# **SERVICE LETTER**

## **No. SL-AG-112**

### **Rewiring the External Power Receptacle (APU) so that the Electrical System is Energized Immediately when Power is Applied to the APU**

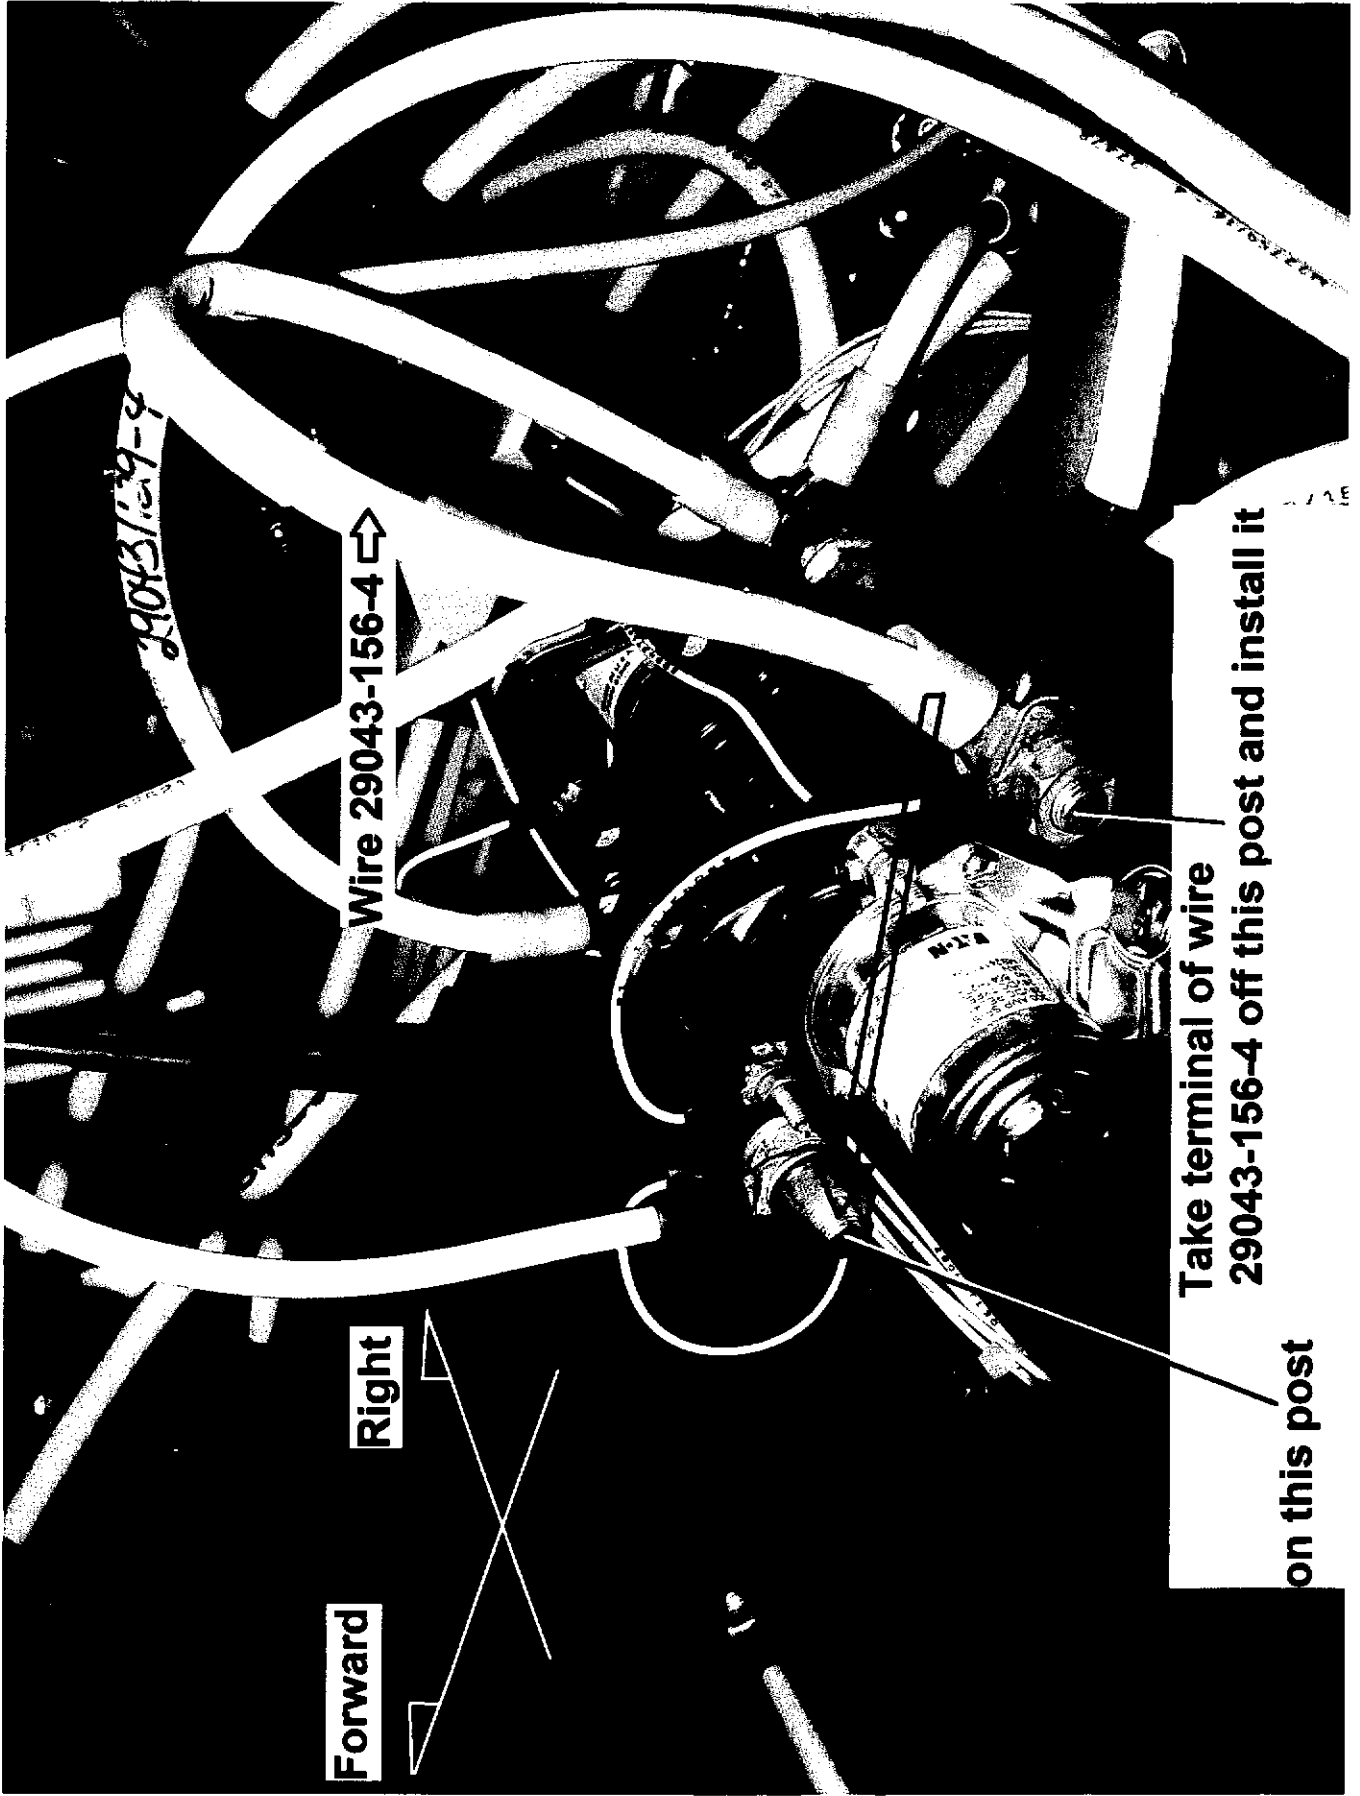
Take terminal of wire  
29043-156-4 off this post and install it

on this post
